Final Environmental Impact Statement for the Mineral Resource Management Plan

Potential Exploration, Development,
and Production of Oil and Gas Resources

Vandenberg Air Force Base

FINAL ENVIRONMENTAL IMPACT STATEMENT

Figure 5-1
PHYSIOGRAPHIC FEATURES
MRMP-2

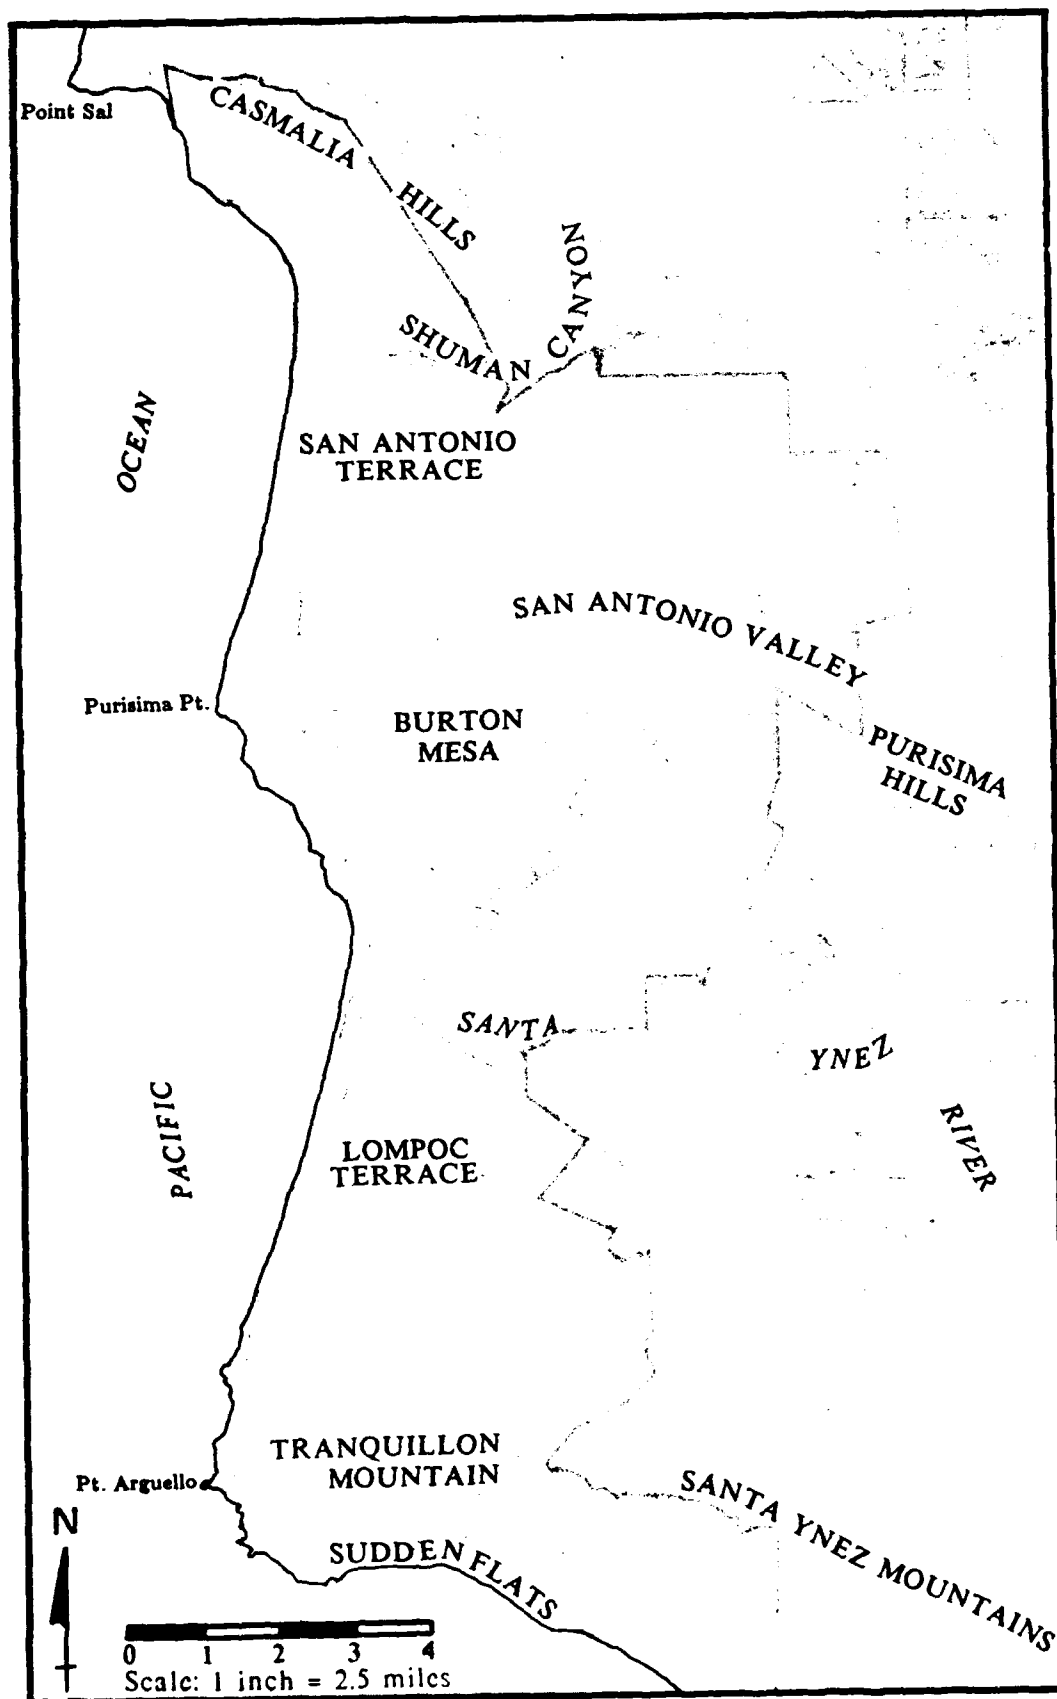
Figure 5-1 - Point Conception is incorrectly located

Figure 5-1 on page 5-2 has been revised. The words "Point Conception" no longer appear (see the attached figure).

Figure 6.5-3
INITIAL COMPLIANCE ACTIVITIES

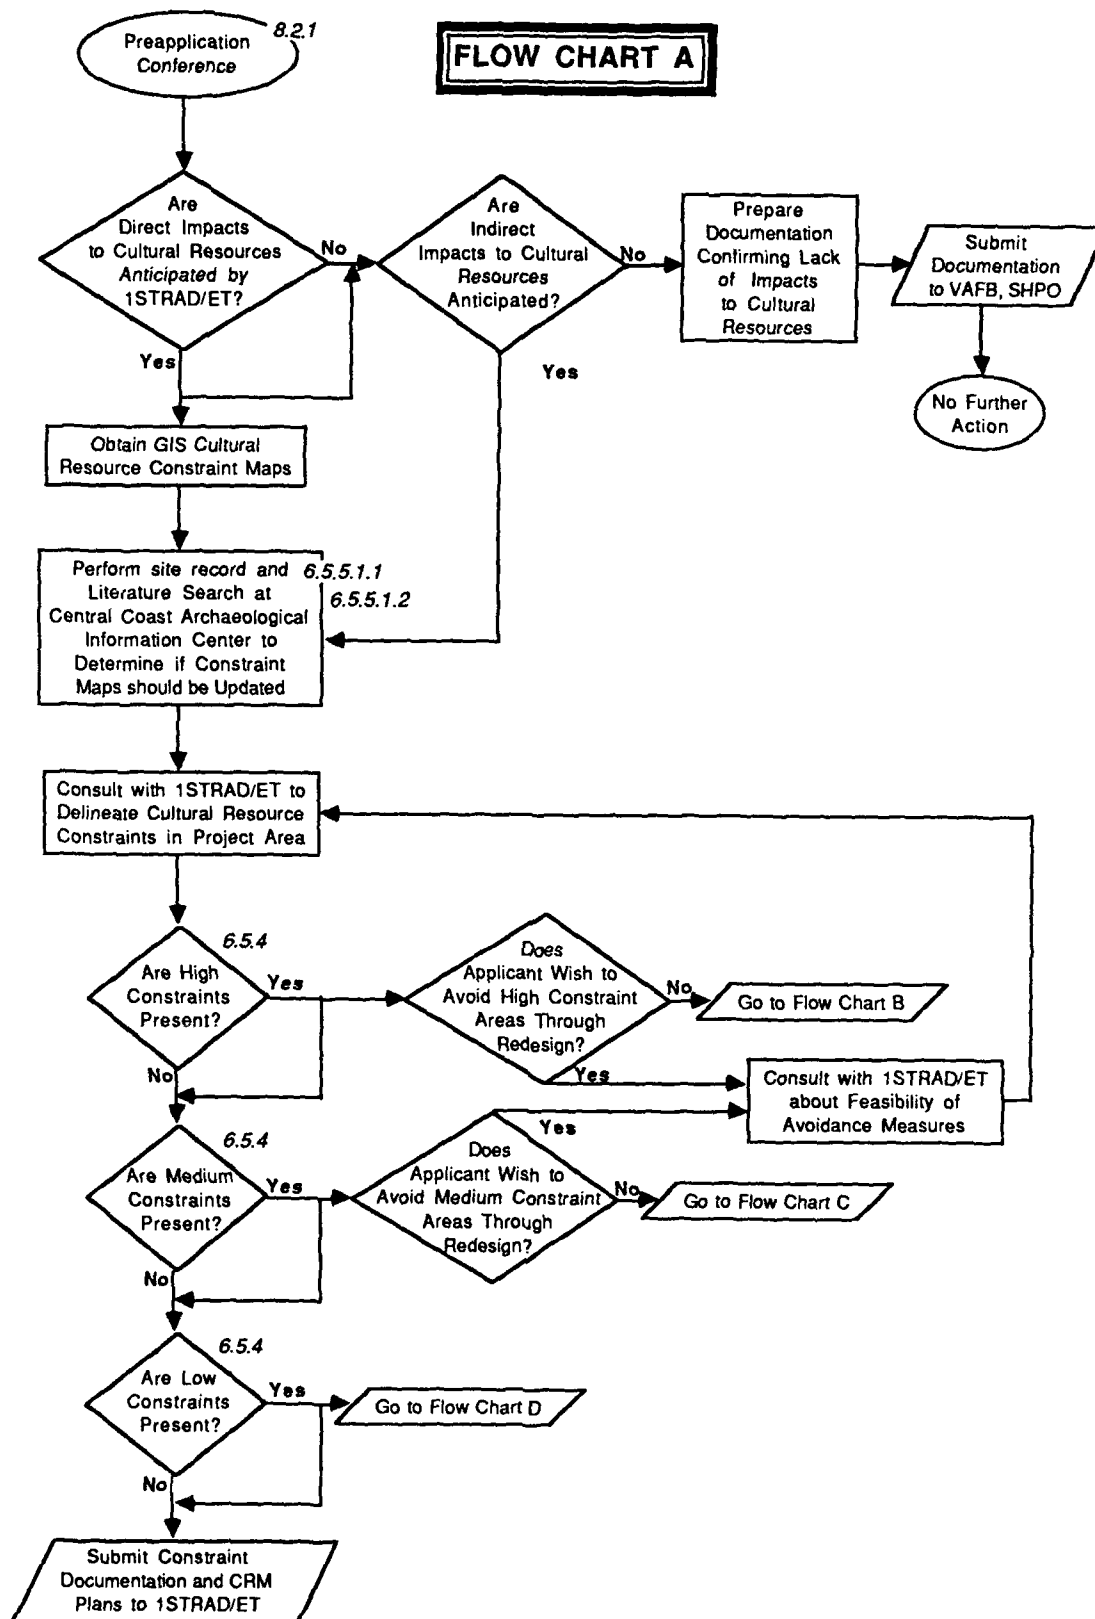
The comment also states that the MRMP does not allow for modification of individual project designs to avoid extensive and expensive site investigations. In fact, the MRMP explicitly sets out compliance activities that focus on avoidance of impacts through redesign *prior* to excavation. For example, Figure 6.5-4 (Flow Chart B) of the MRMP indicates that if a site is present in a project area, it should be avoided through project redesign if possible. Misunderstanding of the procedures may have arisen because this flow chart shows that site avoidance would take place after site boundaries are defined. This is the normal procedure when a redesigned area of potential environmental impact (APEI) is near a site. However, if a project could be redesigned so that the APEI would no longer lie near a known cultural resource, ISTRAD/ET might decide that boundary definition is not necessary. See section 6.5, Cultural Resources, of the MRMP errata for a discussion of when boundary definition may not be necessary.

investigations. Project applicants should consult closely with the U.S. Air Force so that project redesign can be initiated as early as possible. Figure 6.5-3 (Flow Chart A) of the MRMP has been modified to show that avoidance can be implemented after the preapplication conference between the U.S. Air Force and project applicant and before boundary definition is necessary. In this way, an efficient process would be assured. Please see the MRMP errata for section 6.5, Cultural Resources.

Page 6.5-22, Figure 6.5-3 is replaced with the attached.

Figure 6.5-4

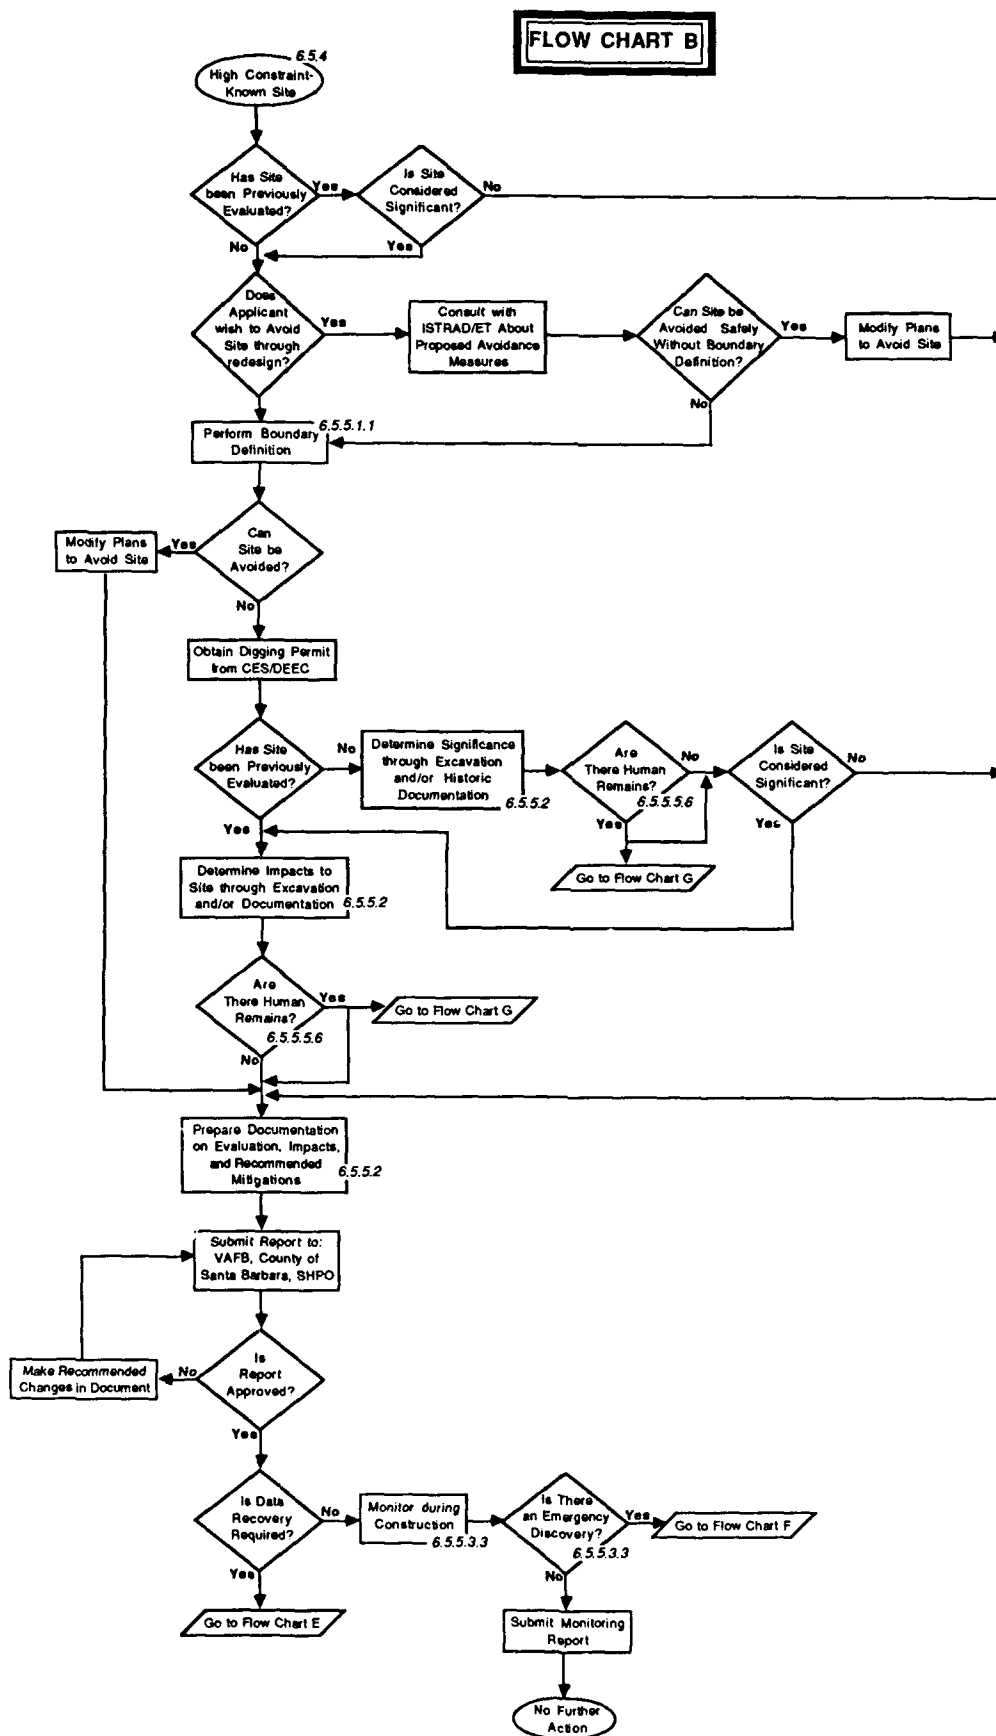
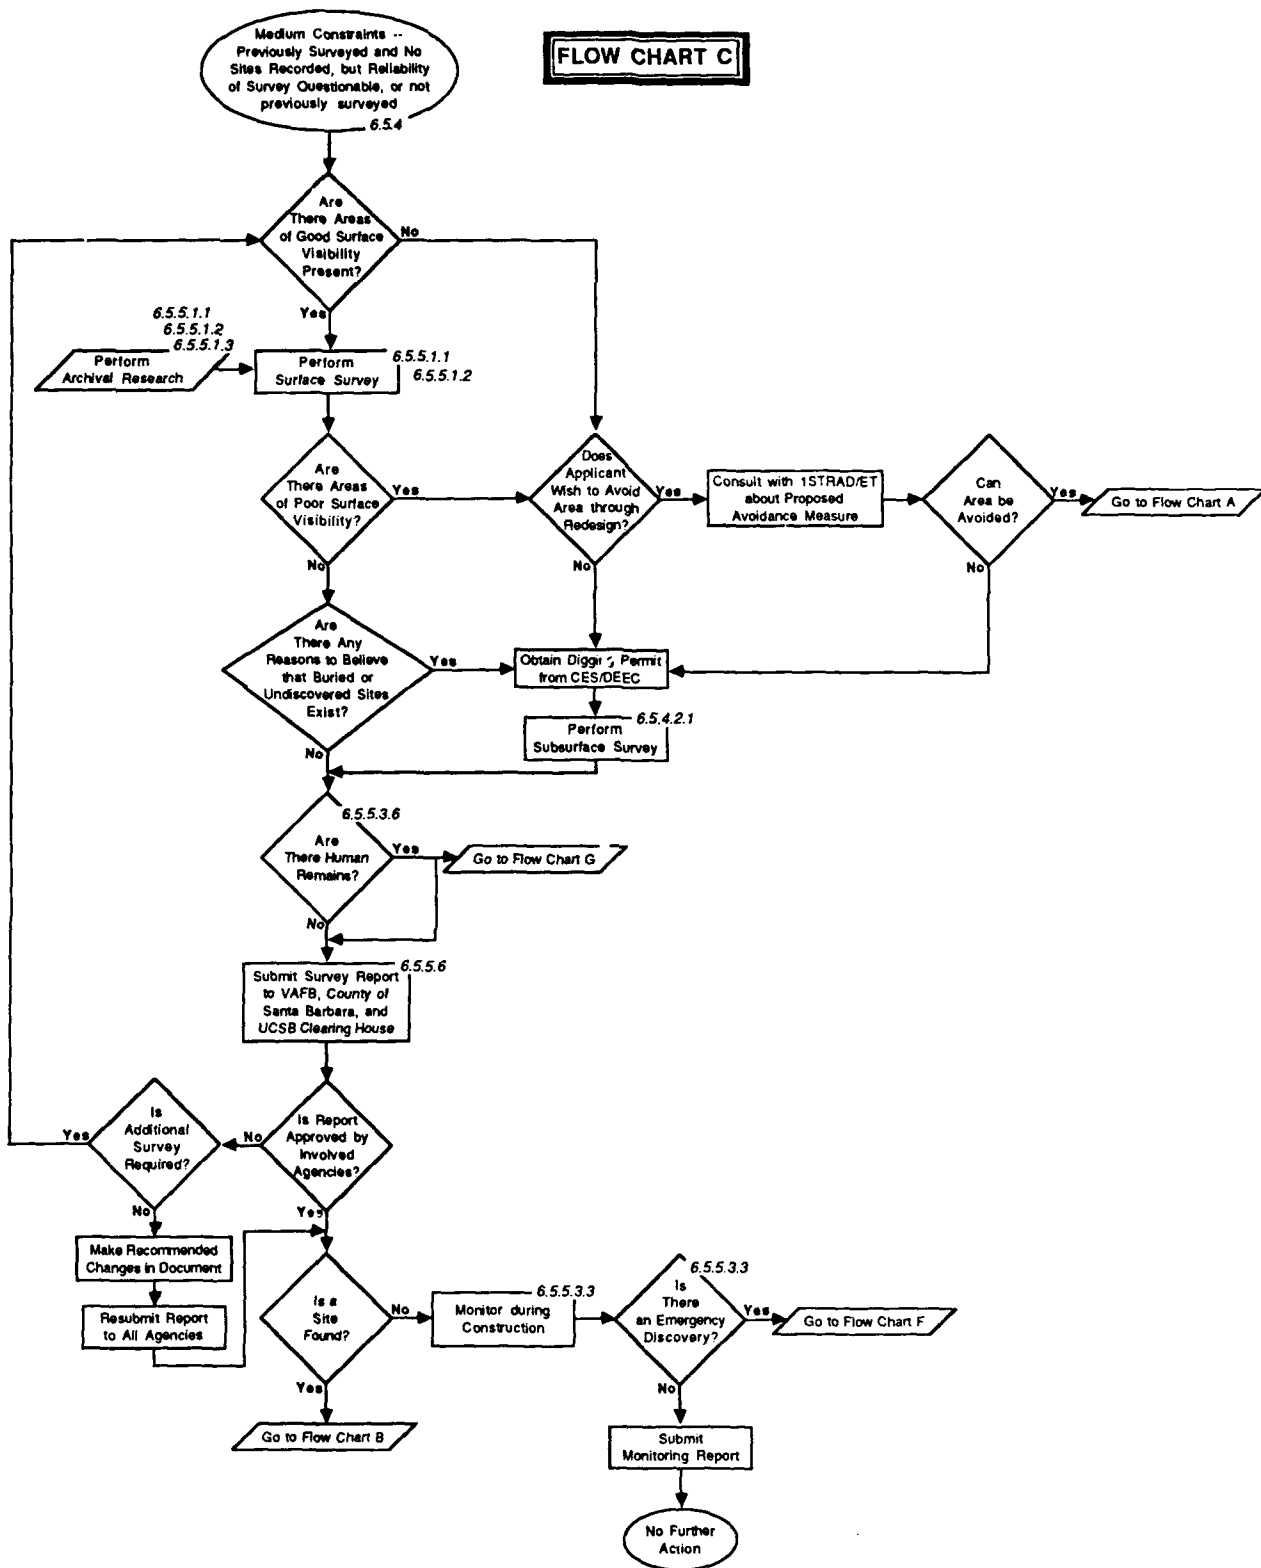
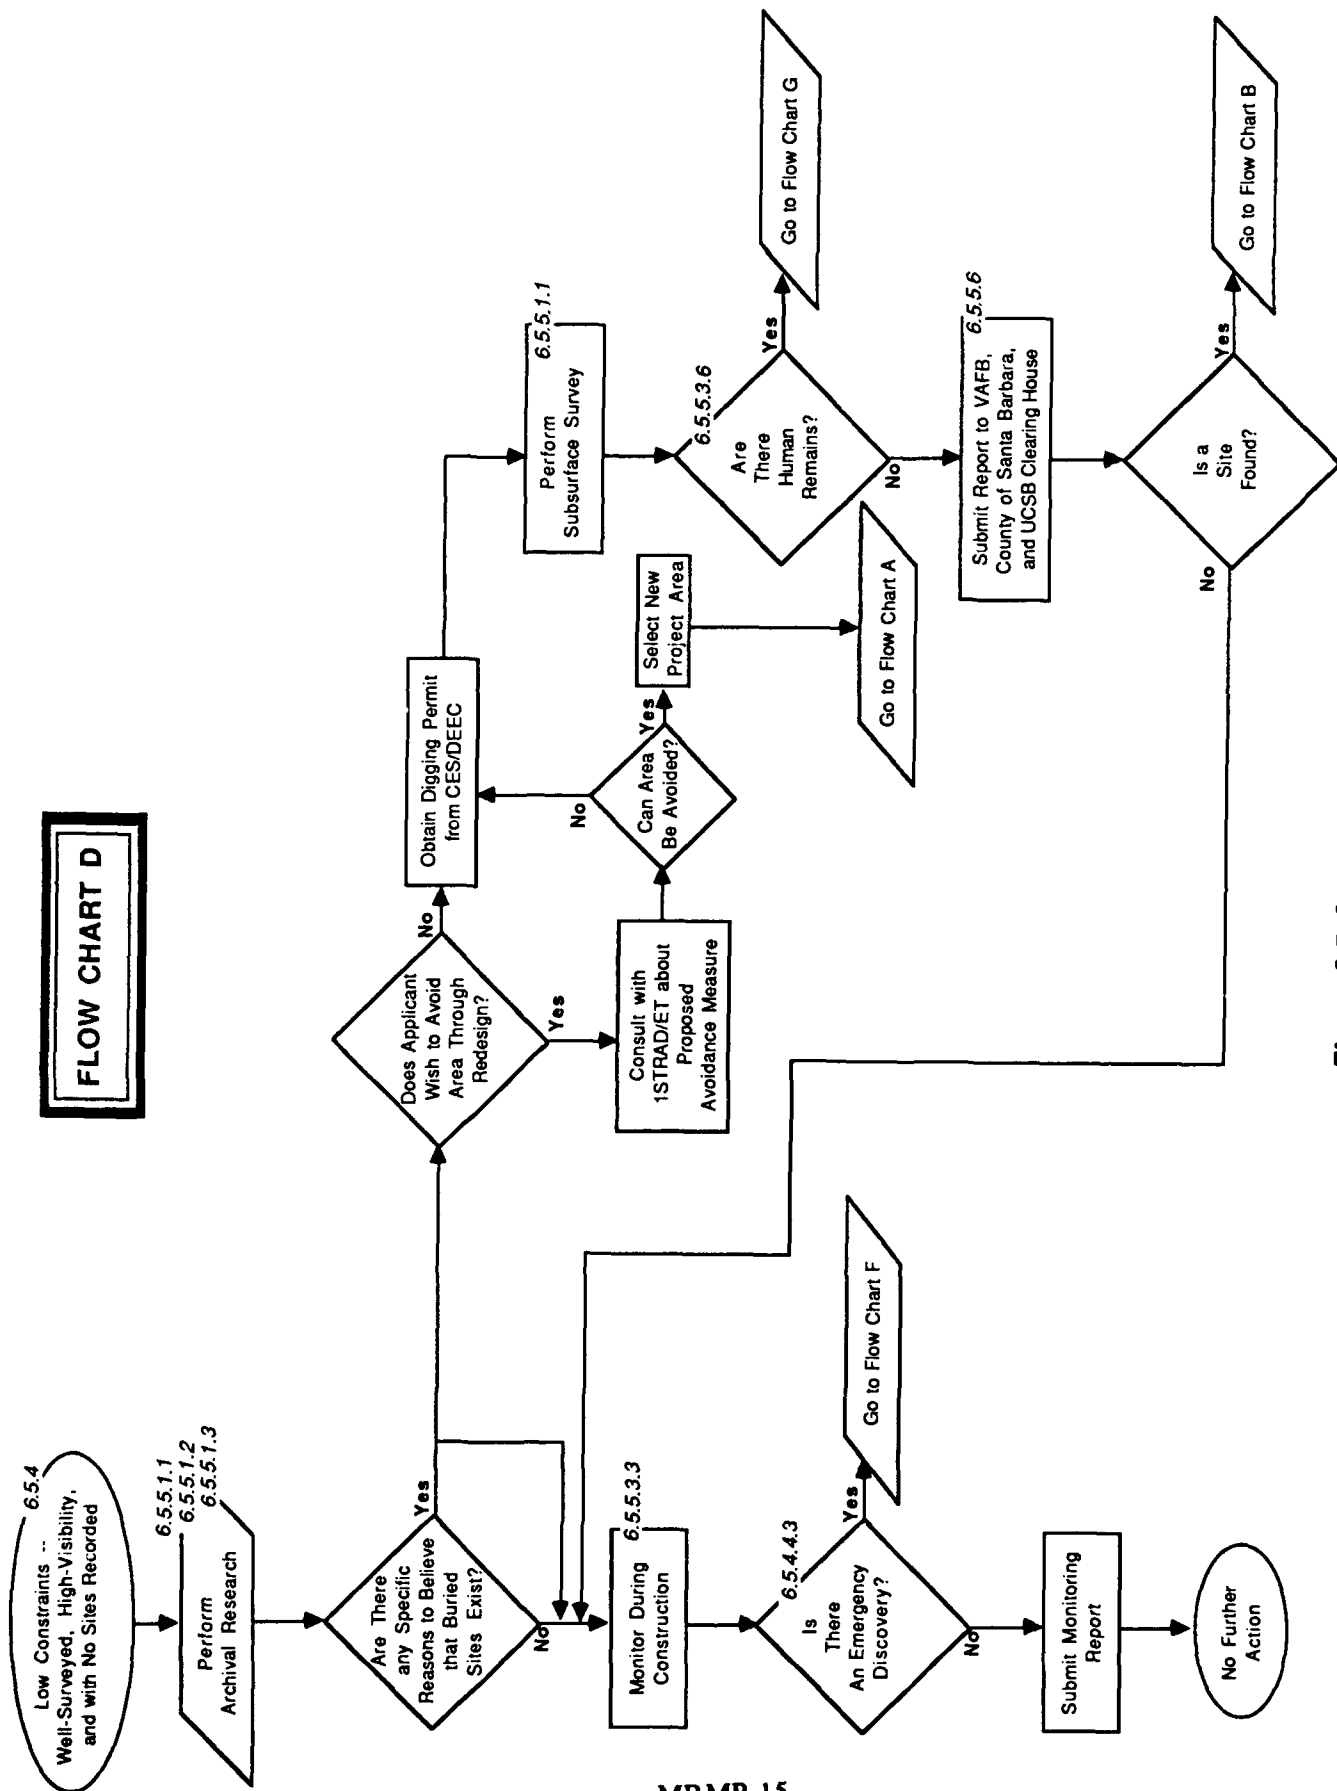
Union-41 The MRMP policies and guidelines are in complete agreement with this comment, and flow charts B, C, and D (Figures 6.5-23, 6.5-24, and 6.5-25) have been modified to show more clearly that project redesign may be implemented prior to the performance of subsurface survey. Please see the MRMP errata for section 6.5, Cultural Resources.

Page 6.5-23, Figure 6.5-4 is replaced with the attached.

Page 6.5-24, Figure 6.5-5 is replaced with the attached.

Page 6.5-25, Figure 6.5-6 is replaced with the attached.
